Project	IEEE 802.16 Broadband Wireless Access Working Group < http://ieee802.org/16 >		
Title	Physical Layer Design Based on Fixed Subcarrier Spacing for Greenfield Deployment without Legacy Support		
Date Submitted	2010-03-15		
Source(s)	Sean Cai, Mary Chion, Huiying Fang, Bo Sun, Jerry Chow, Yang Liu ZTE Corporation Lei Wang InterDigital Communications	E-mail:	scai@zteusa.com Fang.huiying@zte.com.cn leiw@billeigean.com
Re:	IEEE 802.16 Working Group Letter Ballot #31 P802.16m/D4 : 16.3.2.3, 16.3.3, 16.3.5.4.1, 16.3.6.5.1.2		
Abstract	Numerology, Frame Structure, Superframe/Frame configuration and Pilot design based on fixed subcarrier spacing for Greenfield deployment without legacy support		
Purpose	To discuss and accept the proposed solution in this contribution, and adopt the solution text of this contribution into the AWD baseline document IEEE P80216m/D4.doc.		
Notice	<i>This document does not represent the agreed views of the IEEE 802.16 Working Group or any of its subgroups. It represents only the views of the participants listed in the "Source(s)" field above. It is offered as a basis for discussion. It is not binding on the contributor(s), who reserve(s) the right to add,

Figure 465a Basic frame structure for FDD mode

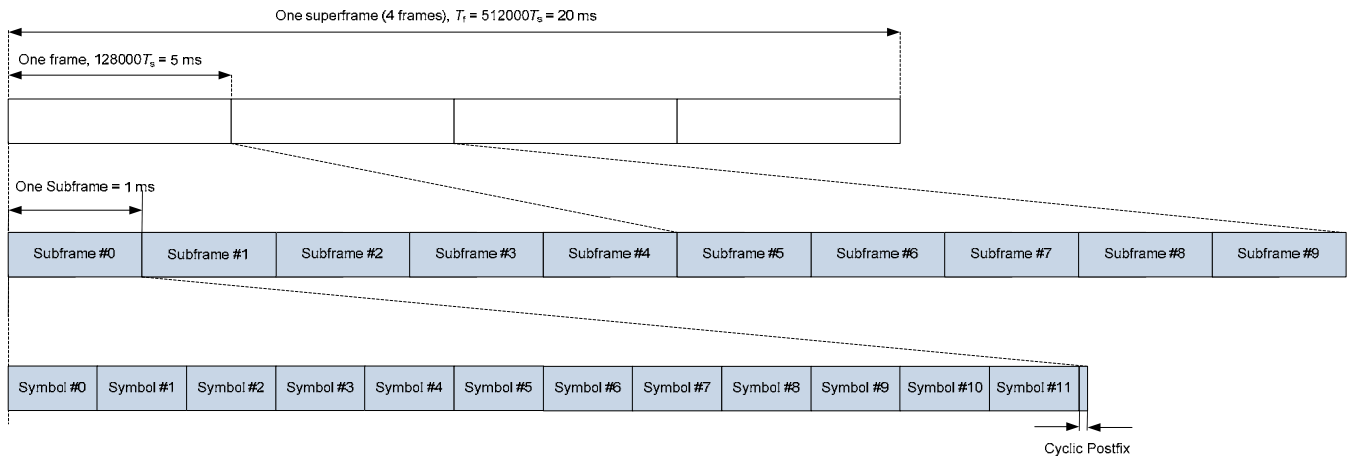
16.3.3.1.1. Basic Frame structure with fixed subcarrier spacing

The advanced air interface basic frame structure is illustrated in Figure 465a for FDD mode and Figure 465b for TDD mode. Each 20 ms superframe is divided into four equally-sized 5 ms radio frames. Each 5 ms radio frame further consists five equally-sized 1 ms subframes. According to the different configurations in Table 779a, the number of symbols in a subframe can be different.

Figure 465b. Frame Structure Type for TDD mode

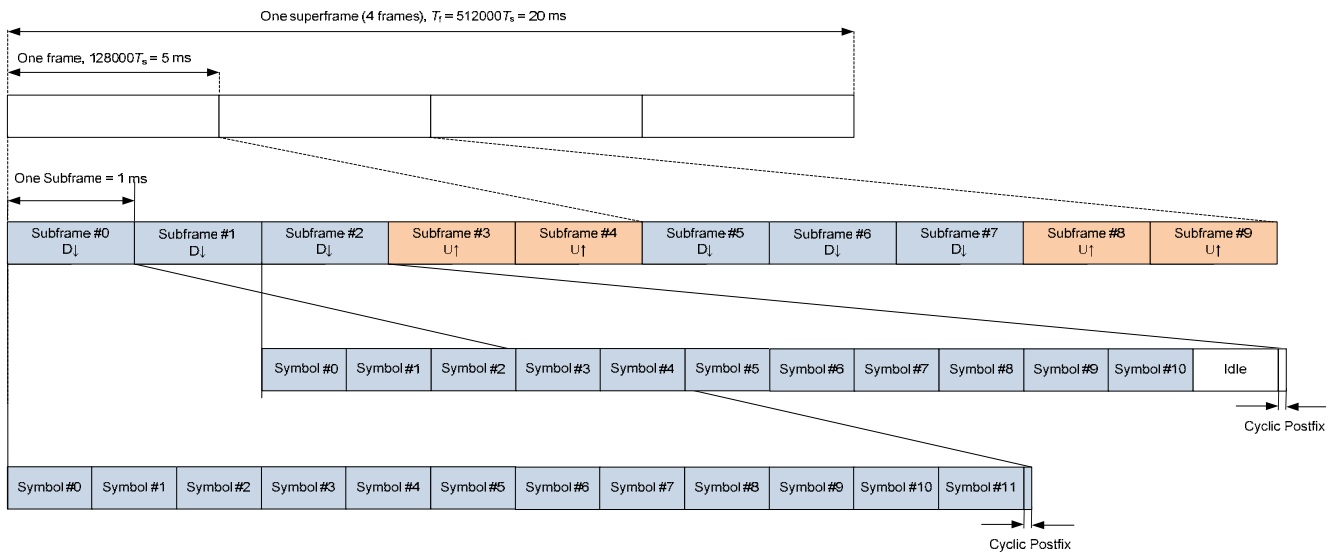
For Type TDD mode, a subframe is also the smallest unit to be configurable for downlink and uplink transmission. As shown in Figure 465a, Subframe# 0 is always reserved for downlink transmission. Starting from Subframe# 1, each subframe can be configurable for downlink or uplink transmission. For each subframe in a radio frame, “D” denotes the subframe is reserved for downlink transmission, “U” denotes the subframe is reserved for uplink transmission. The concept of slots is only used to describe the dimensions of resource blocks.

Downlink-uplink configurations with 5 ms, 10 ms, and 20 ms downlink-to-uplink switch-point periodicity are supported. In case of 5 ms downlink-to-uplink switch-point periodicity, the switch-point exists in each frame. In case of 10 ms downlink-to-uplink switch-point periodicity, the switch-point exists in only one of the two frames. In case of 20 ms downlink-to-uplink switch-point periodicity, the switch-point only exists in one of the four frames. Multiple switch-points are also supported within a 5-ms frame as optional features to support such as extremely high mobility performance where very fast feedbacks are required. Table ggg shows superframe configuration, where “D” denotes the frame is reserved for downlink transmission, “U” denotes the frame is reserved for uplink transmission. “X” and “Y” denotes the frame can be configured as indicated by the Frame Configuration Index. The detail frame configurations are shown in Table hhh.

Figure 465c Frame structure with special subframe

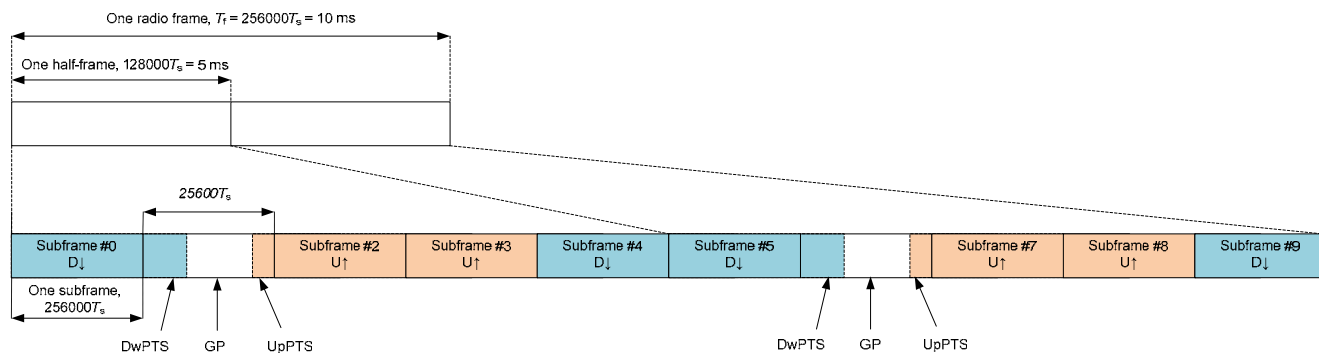
“S” denotes a special subframe with the three fields DwPTS, GP and UpPTS. The length of DwPTS and UpPTS is given by Table 779c subject to the total length of DwPTS, GP and UpPTS being equal to 1 ms. Subframes 0 and 5 and DwPTS are always reserved for downlink transmission. UpPTS and the subframe immediately following the special subframe are always reserved for uplink transmission. In case of FDD, operation with half duplex from UE point of view is supported.

Figure 465d. Superframe & frame configurations with trie data structure

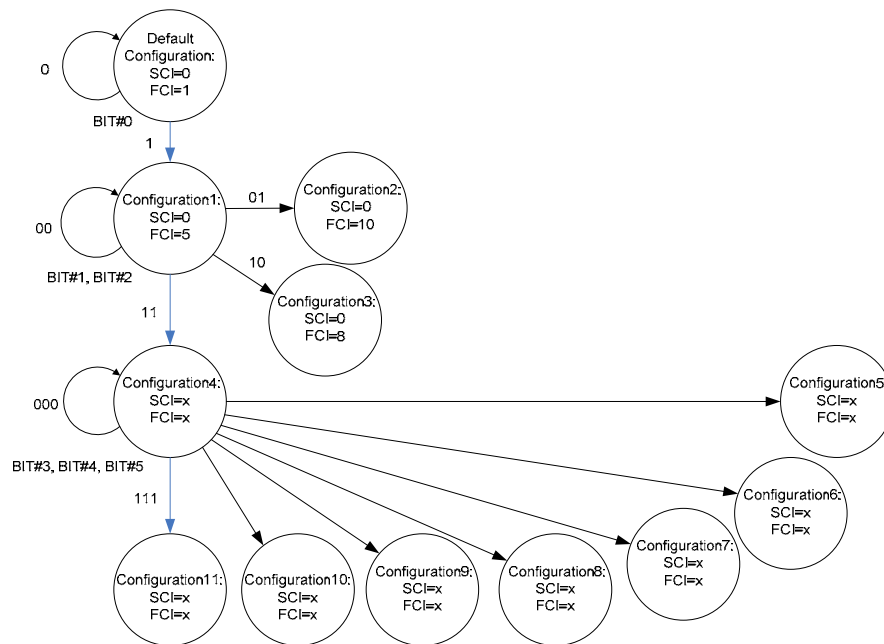
When a network is deployed, a superframe is often configured to a default system profile. However, a superframe can change its frame structure via superframe control signaling. There are many different superframe and frame configurations are available for different networks deployment. However, it is believed that only limited set of configurations are practically used within a particular network. In order to minimize the number of bits for superframe and frame configurations to be transmitted in the air by superframe header the trie data structure is used to broadcast configurations information. If the network is operating in default configuration, only one bit is transmitted in the air to indicate that the superframe and frames are configured in default mode. The example is shown in Table iii; the values of Superframe Configuration Index (SCI) and Frame Configuration Index (FCI) in the Figure 465d are selected for illustration purpose.

Figure 516a. Pilot patterns for 1 and 2 data streams

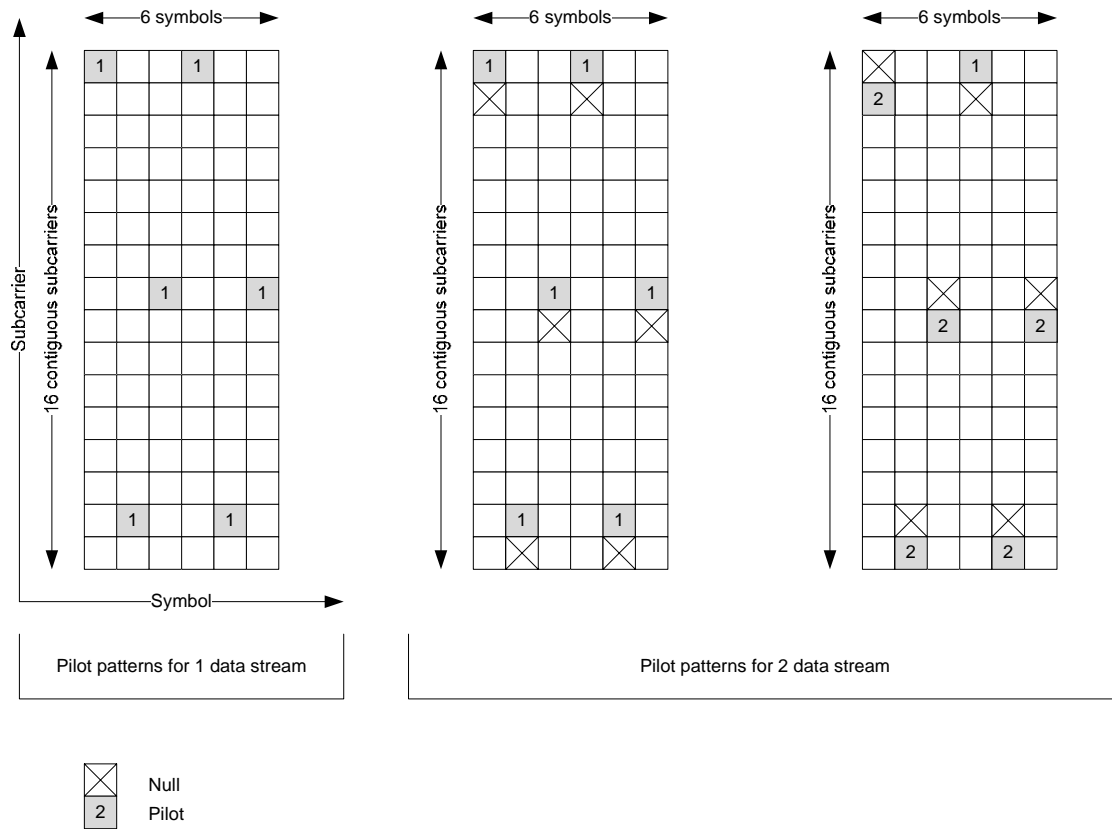
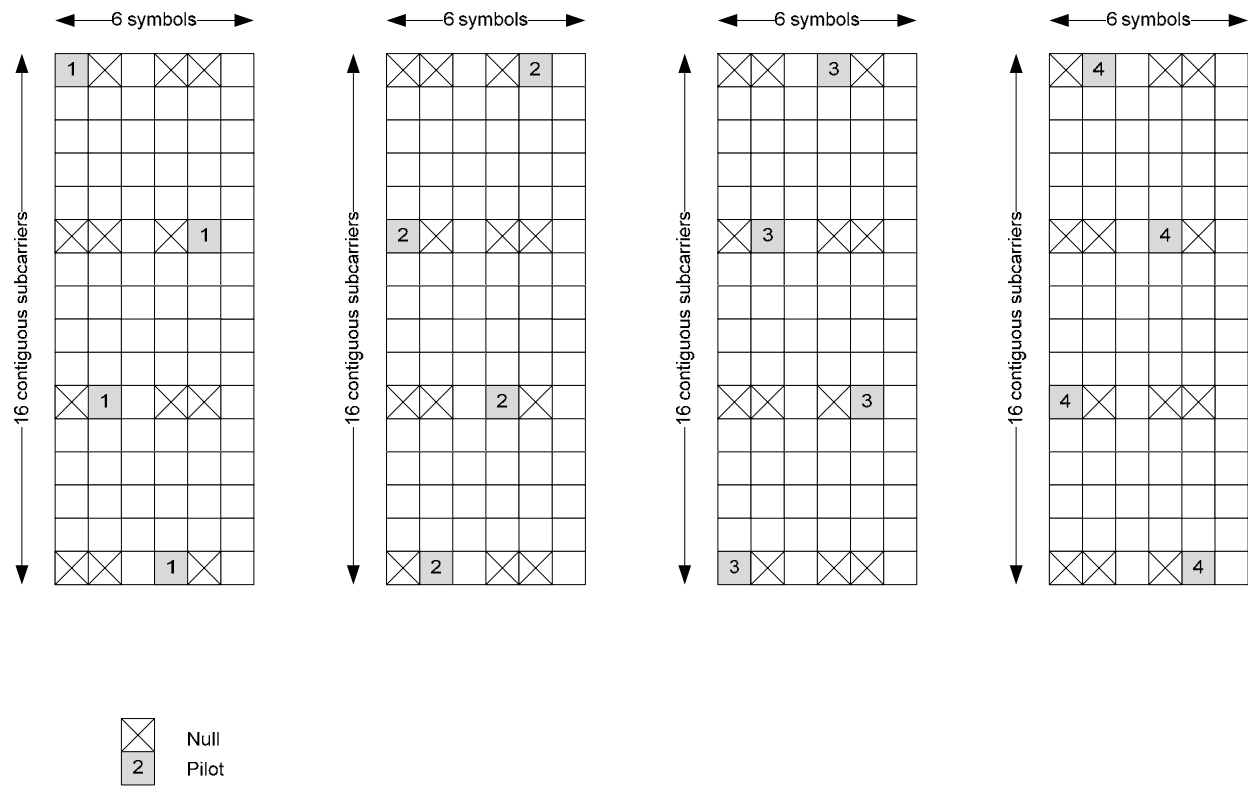
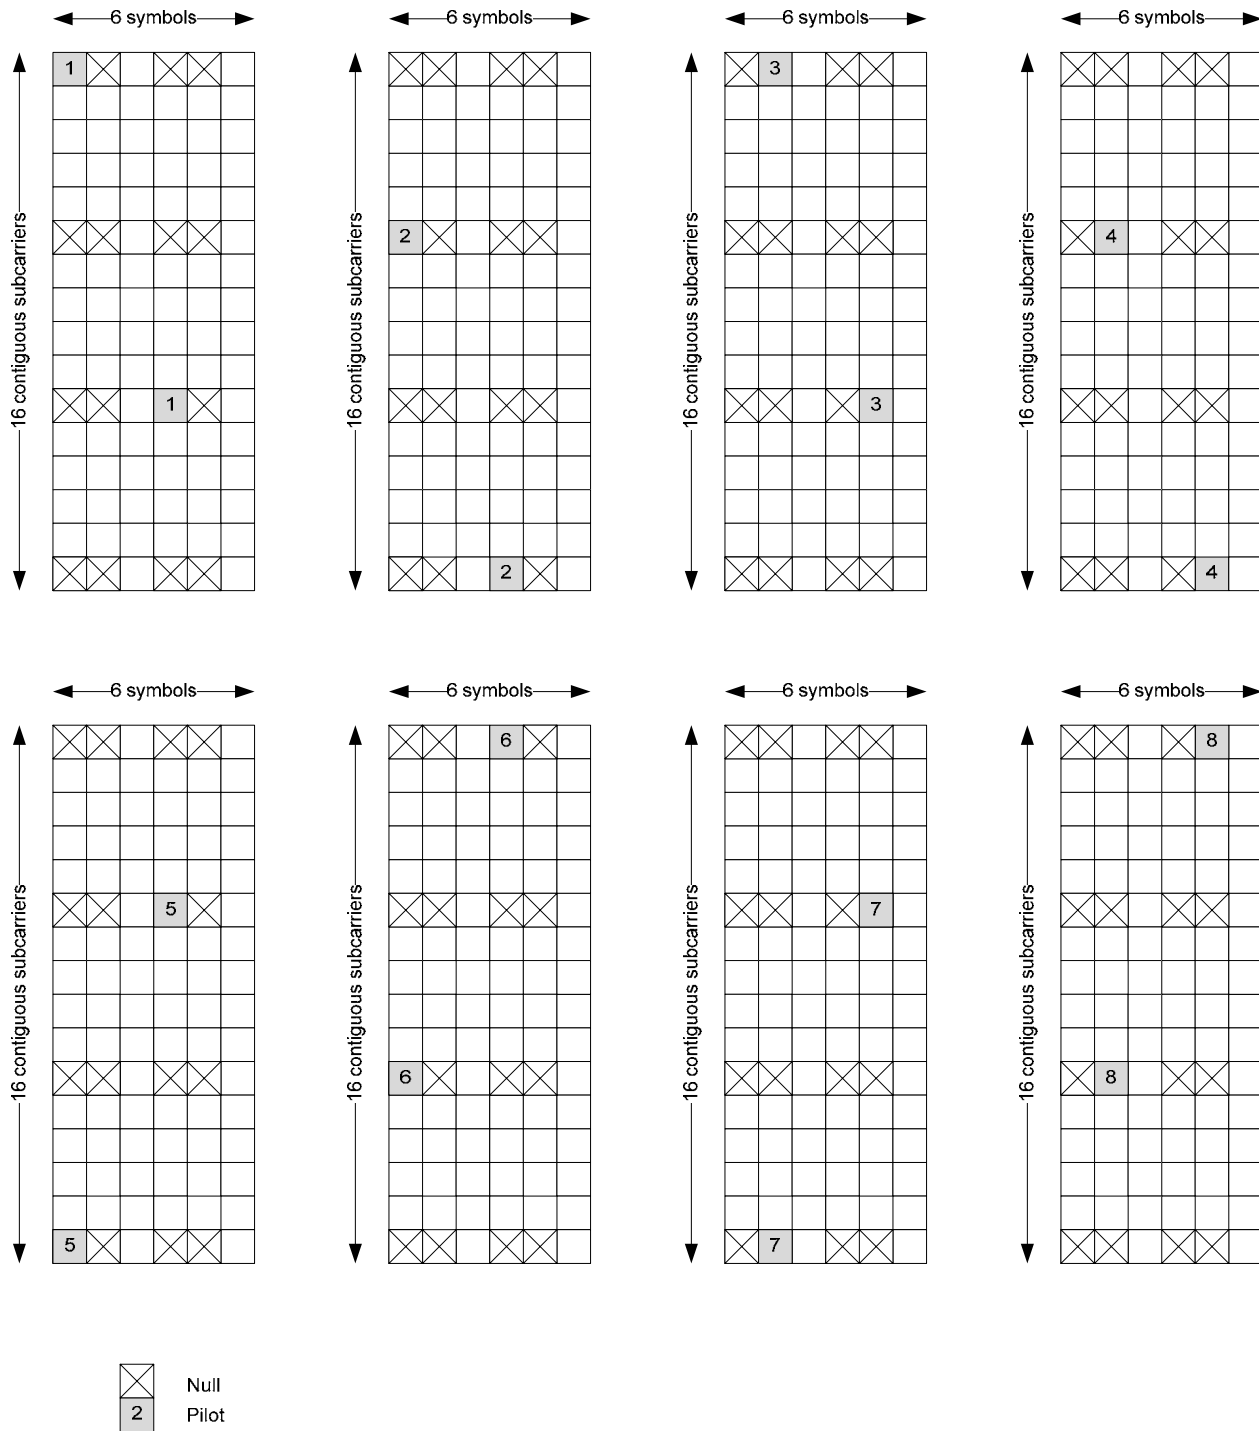
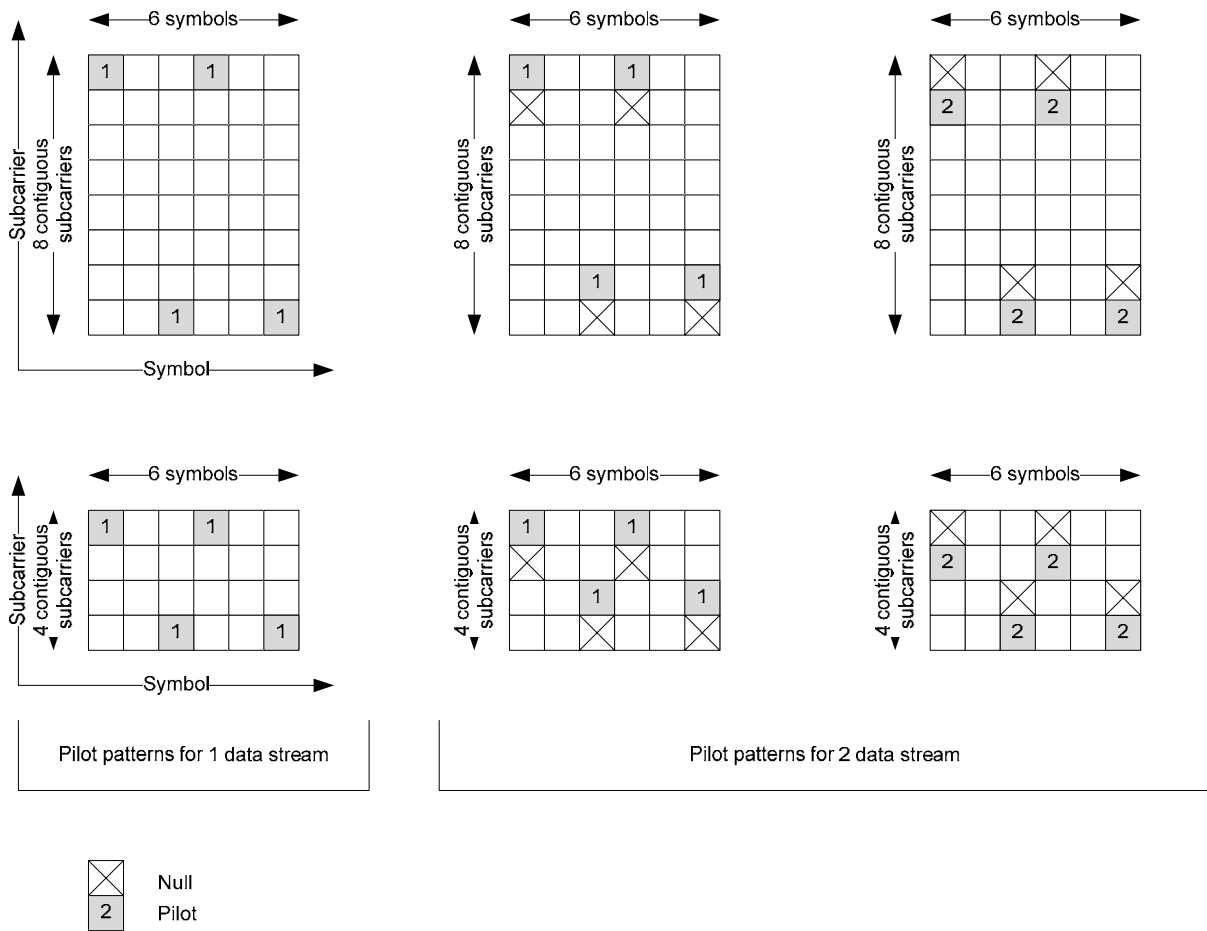
16.3.2.4.1.1 Pilot patterns for fixed subcarrier spacing

The pilot patterns are specified within a PRU.

For $N_{\text{symb}}=5$, the last symbol of the pilot patterns as shown in Figure iii or Figure jjj is deleted. Similarly for $N_{\text{symb}}=3$, the last three symbols of the pilot patterns are deleted.

For $N_{\text{symb}}=5$, the last symbol of the pilot patterns as shown in Figure kkk, or Figure lll is deleted. Similarly for $N_{\text{symb}}=3$, the last three symbols of the pilot patterns are deleted.
